INDOOR AIR QUALITY [IAQ] EVALUATION AND HVAC SYSTEM ASSESSMENT

Madison Neck River Elementary School

Submittal #23 05 93-7.0 23 05 93 - TESTING, ADJUSTING, AND BALANCING FOR HVAC

Project: J09867.000 - Madison New PreK-5 Elementary School
Mungertown Road
Madison, 06443

SHEET NO. 51R

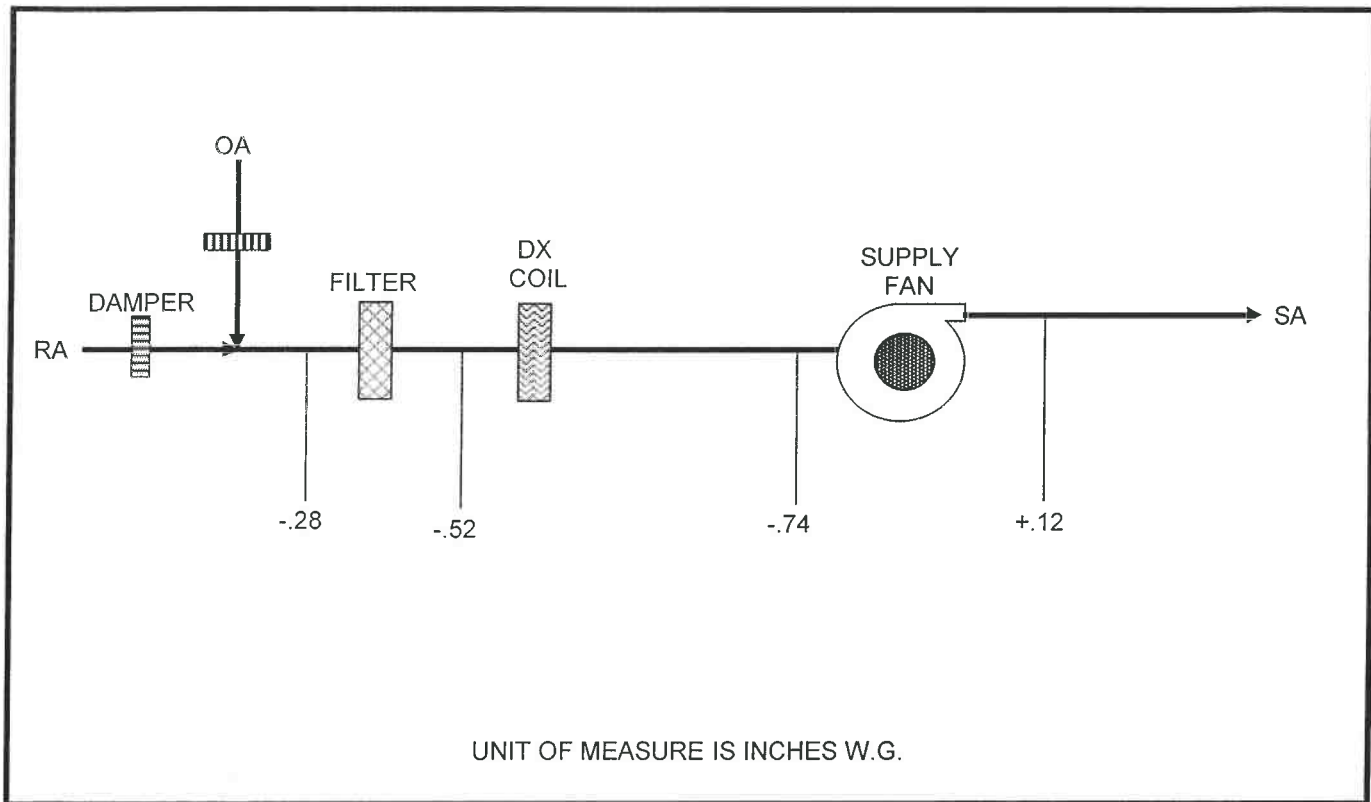
GBC: Update values per findings recorded during April 2026 visit

SHEET NO. 53R

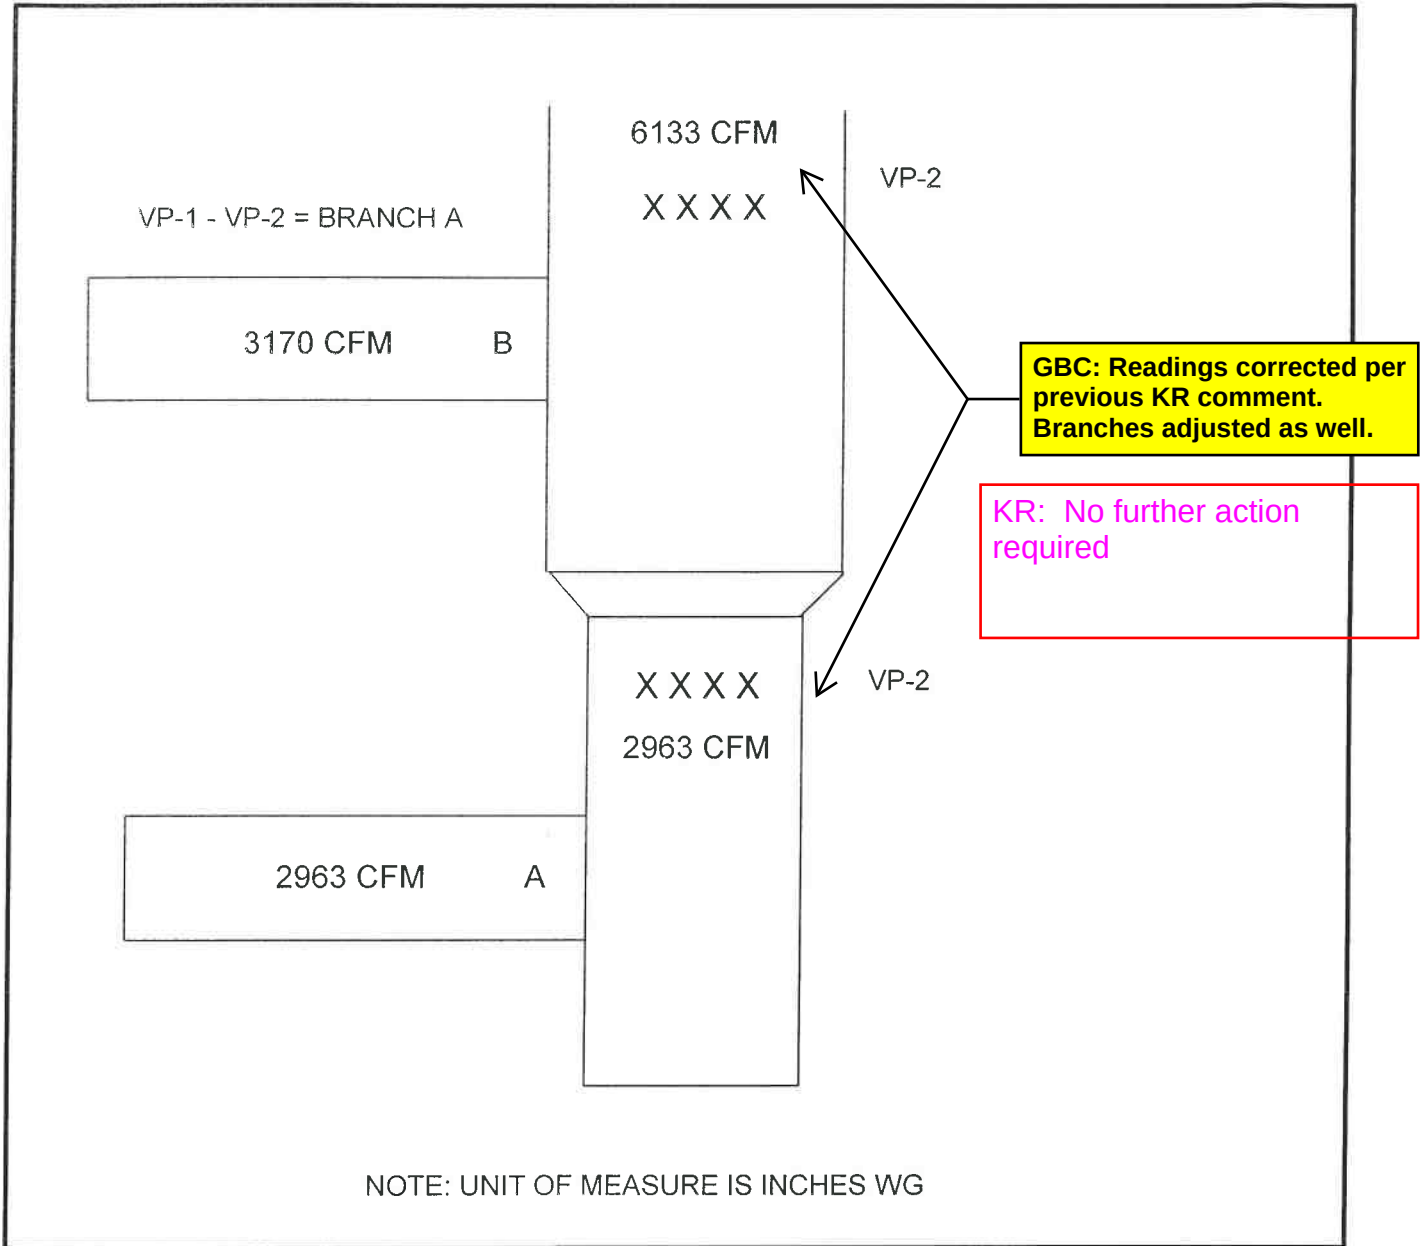
GBC: Updated April 2026 readings are notably closer to design values.

GBC: Updated readings taken in April 2026 align with HP-M-1.

KR: No further action required
